CIIPC Cover Letter

This CIIPC was initiated on behalf of Sirius XM Satellite Radio to support the changes being executed on the Bluetooth Vehicle Dock (RS2SXBTD1). A summary of the changes are mentioned below, but could also be referenced in detail from the supporting test report accompanying this application.

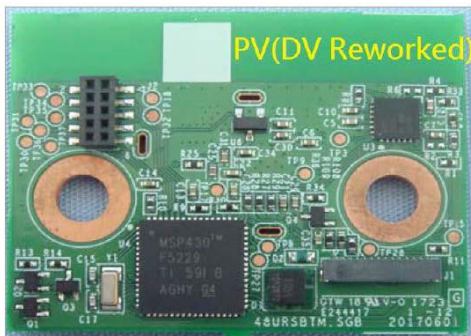
Component changes to improve overall performance of the device.

Schematic:

1. Changed the value of R108 to 1.2Kohm.
2. Changed the value of R109 to 270Kohm.
3. Removed U4, C18, C19, C14, R10, R12, R15 and R30.
4. Removed R25, R27, R28 and R29.
5. Added Q206, Q209, D3, U9, U10, U11 and U15.
6. Added R111, R128, R129, R130, R131, R132, R133, R114 and R113.
7. Added C36, C43, C38, C39, C40 and C41.
8. Added J6.
